<b>Attention:</b>	Kelly Van Marter, AICP Planning Director and Assistant Township Manager
<b>Subject:</b>	Aldi Food Market – Site Plan Review #1
<b>Location:</b>	2260 E. Grand River Avenue - south side of Grand River, west of Chilson Road
<b>Zoning:</b>	GCD General Commercial District

**Re: Aldi Expansion Site Plan Review #1**

The enclosed Site Plan has been revised to address review comments prepared by the Township consultants. In response to the LSL Planning, Inc., review letter dated February 14, 2018 we offer the following (please refer to the numbered summary items on the review letter):

EX1

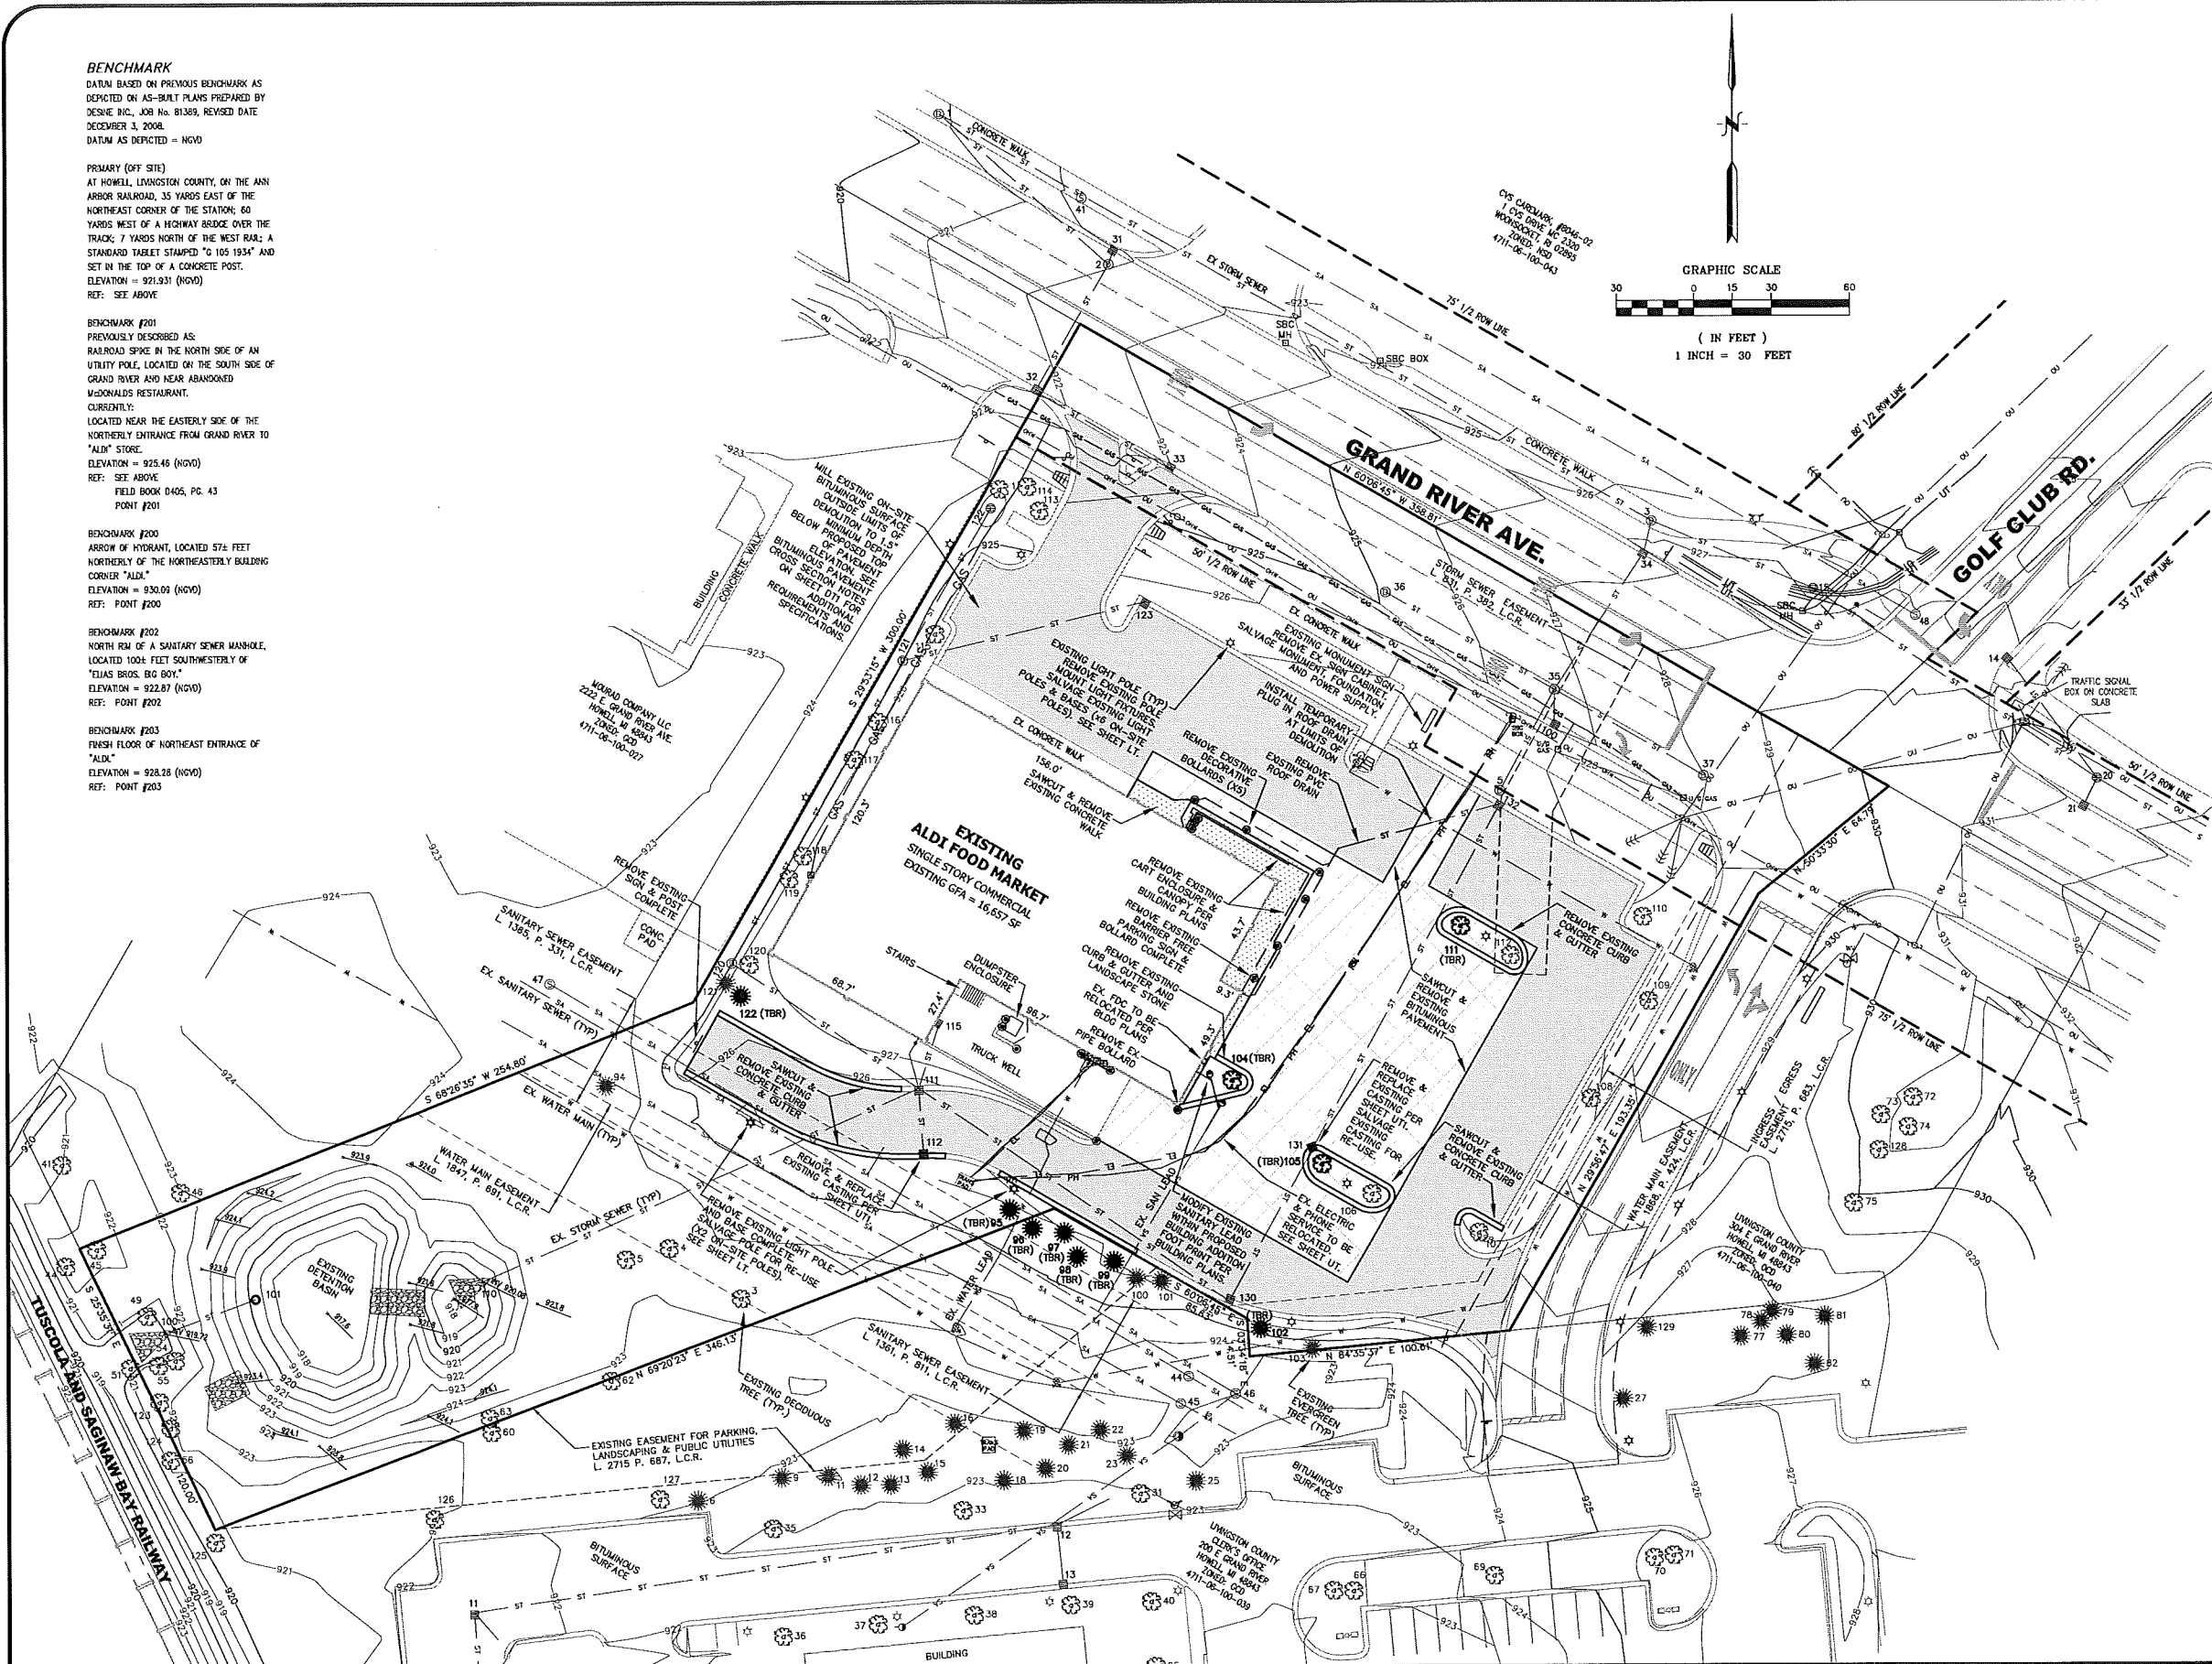
- o A detention basin shall have a minimum of 1-foot free board above the 100-year storage level. The proposed 100-year elevation is 922.7 while the site plan shows the highest elevation of the detention basin is 923.

- o Additional spot grades have been added to Sheet EX1 around the existing detention pond to more accurately reflect the existing ground elevation. The existing detention basin provides the required 1-foot free board above the 100-year storage elevation.

UTILITY PLAN

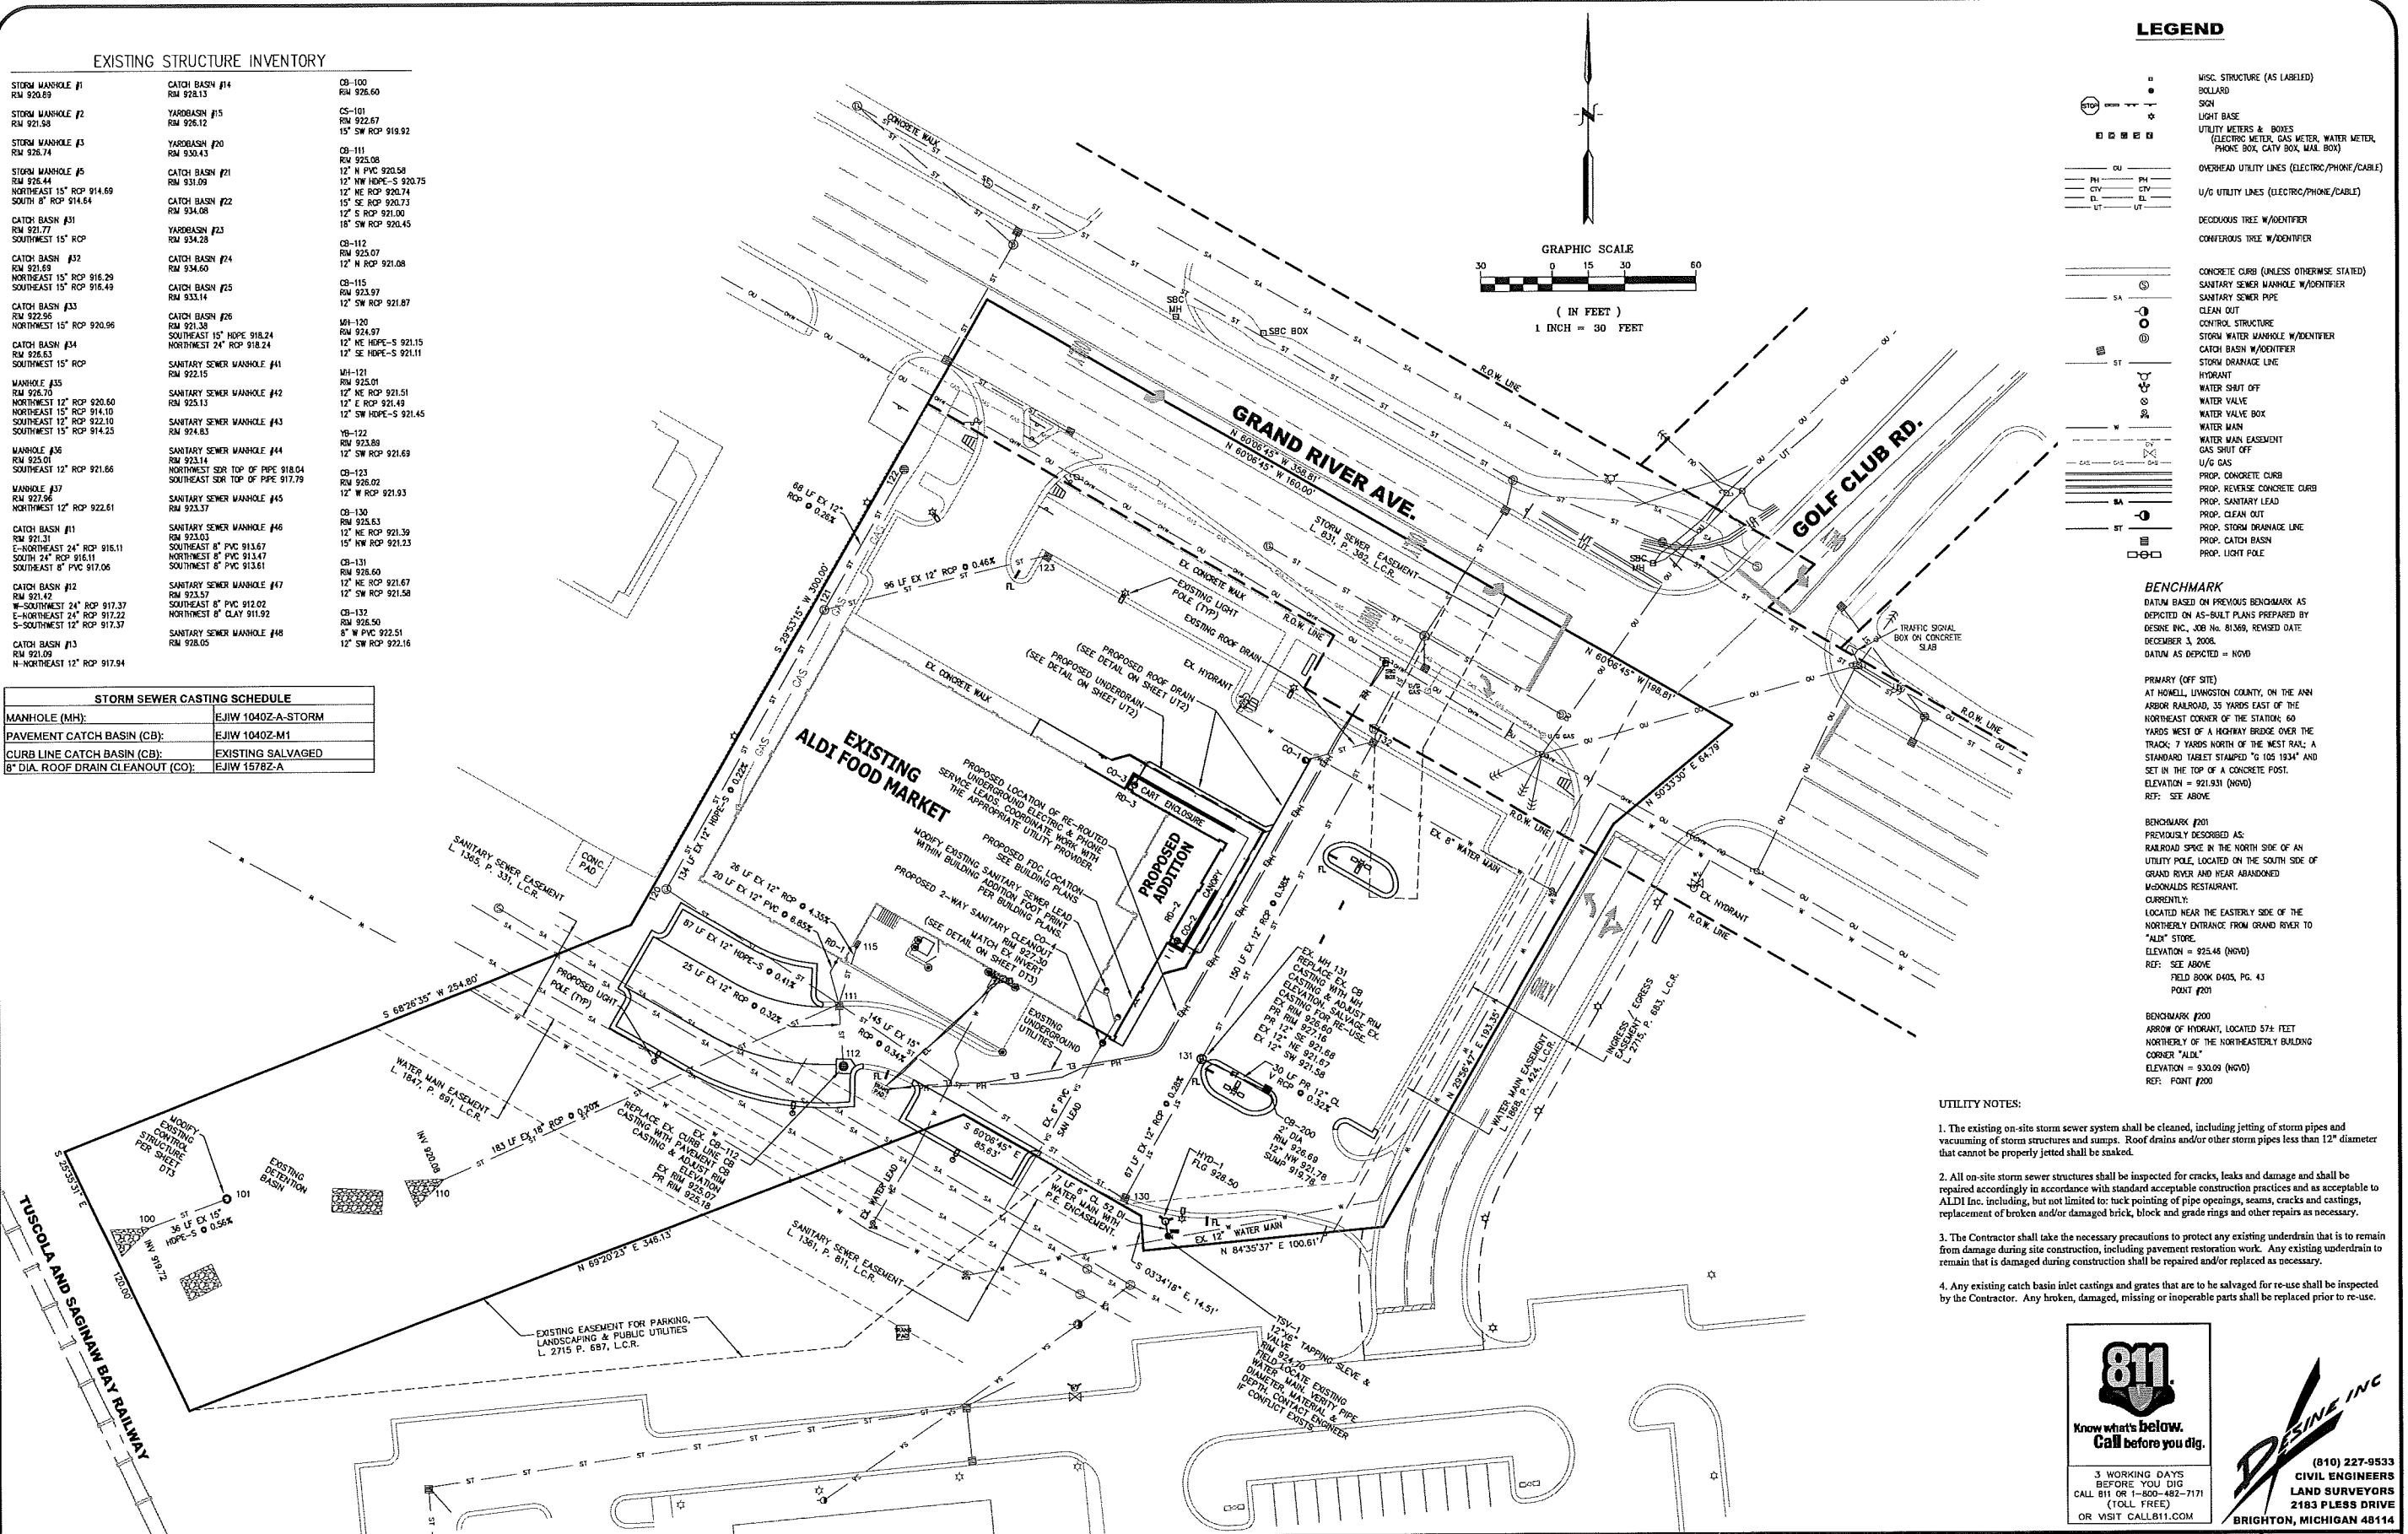
- The petitioner has not accurately calculated the ‘bankfull’ flood volume. It should be calculated using “ $8160 \times A \times C$ ”. This will affect the elevation and size of the outlet holes in the discharge standpipe. Due to the detention basin requiring expansion, the discharge standpipe elevations and hole sizes will need to be recalculated and likely revised in the field. In addition, a standpipe detail showing the discharge holes will need to be added to the plans.

- o The existing Detention Volume Calculations and Control Structure Calculations have been updated on Sheet UT2. The Control Structure will be modified to provide the required detention pond storage volume. A Control Structure Modification Detail has been added to Sheet DT3 to depict the proposed structure modifications.

- o The Control Structure Calculations on Sheet UT2 have been revised to reflect the noted Bankfull Flood Volume calculation change. A control structure standpipe detail, CS-101, has been added to sheet DT3.

LA1

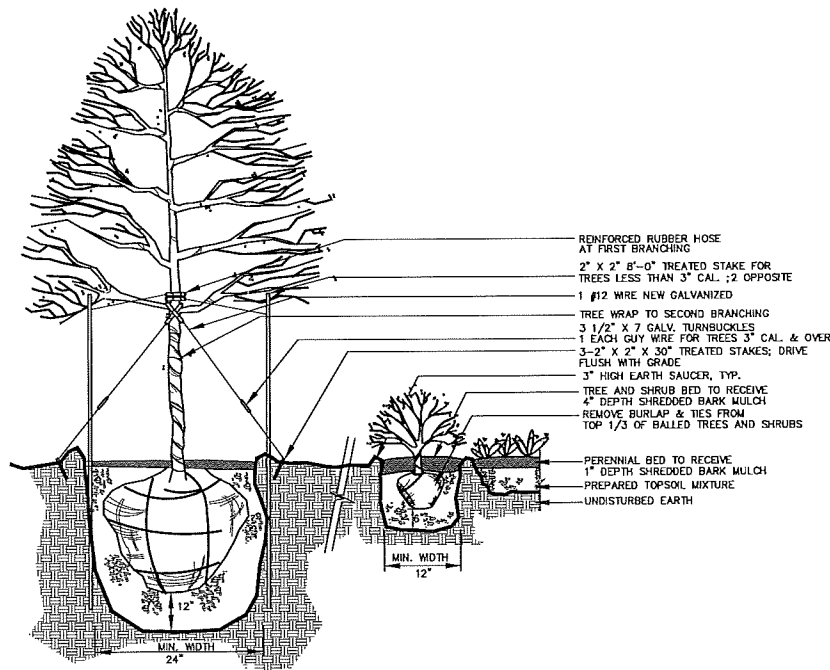
1. The proposal includes parking spaces across a property line. While this area is covered with an easement for such, it does not comply with the setback requirements for parking lots.
2. The Planning Commission has approval authority over the building elevations, including materials and colors.
3. The amount of parking proposed (125% of the minimum) exceeds the maximum allowed by Ordinance (120%). The applicant must either remove at least 4 spaces or demonstrate to the Planning Commission why the additional spaces are necessary.
4. Items #1 and #3 could be mitigated by the removal of the 6 spaces described above.
5. The Commission may wish to require looped striping for the parking spaces.
6. The greenbelt and parking lot landscaping include evergreen and ornamental trees, whereas the Ordinance requires canopy trees (2.5” deciduous).

1. We are requesting a variance to the property line setback for parking to allow the proposed parking spaces within the existing parking easement.
2. We concur. Please note materials on the proposed expansion will match existing building.
3. ALDI, Inc. requires new stores to provide 1 parking space per each 200 square feet of the total building area.
4. See comments #1 and #3, above.
5. We have noted the looped striping for the parking spaces on Sheet SP, Note 8.
6. Pertaining to the greenbelt landscaping, it was determined that Evergreen trees would be acceptable to screen adjacent properties. Ornamental trees size has been revised to 2.5" caliper. Refer to Table on Sheet LA1.
